Request: Minor Modification to PD 22-0719

**Proposed PRS 25-1056** requests to amend the existing Conditions of Approval to eliminate the sidewalk requirement along U.S. Highway 92. No other changes to the PD are requested.

PETITION NO: RZ 25-1056

## 2.2 Immediate Area Map

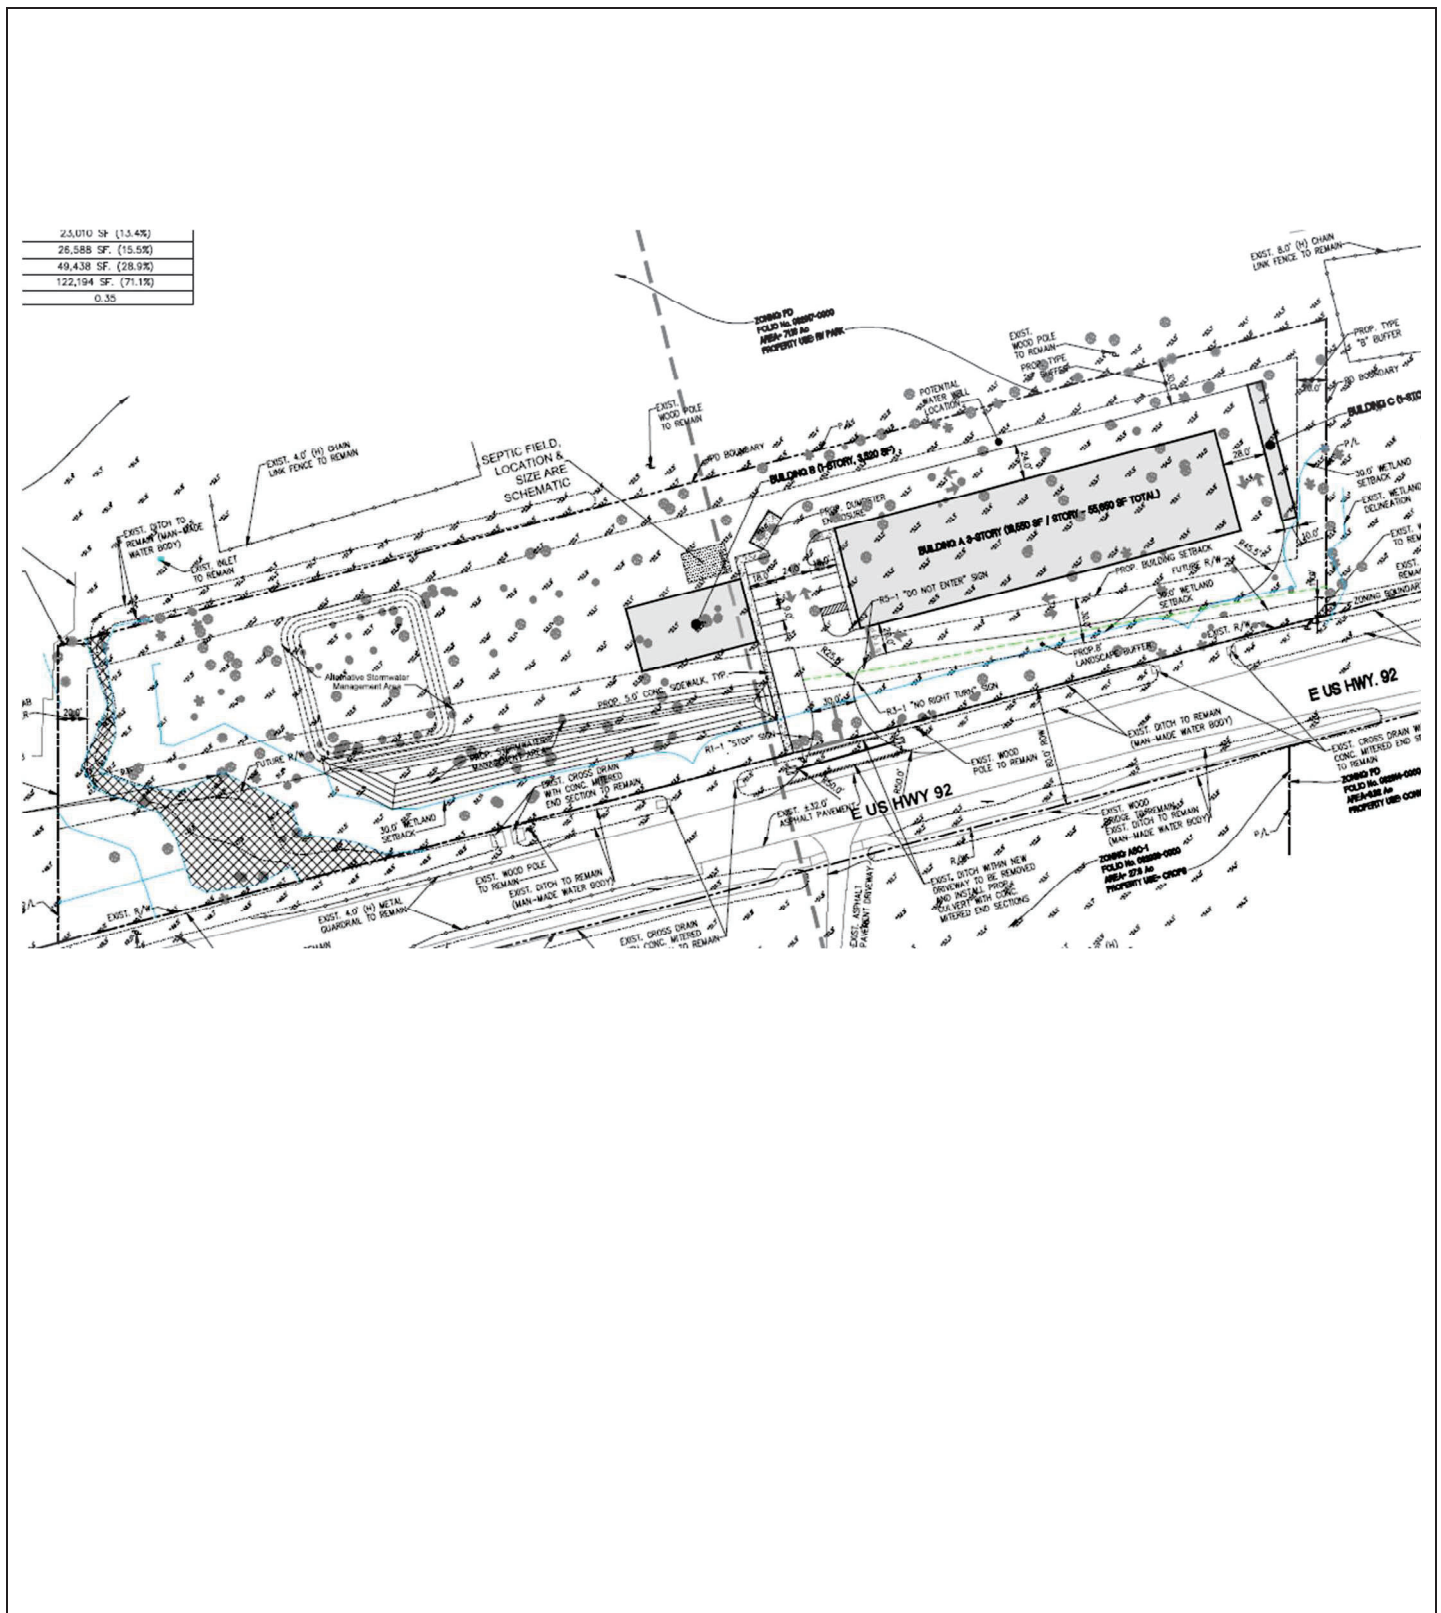
The applicant is not proposing any changes to the approved Site Plan.
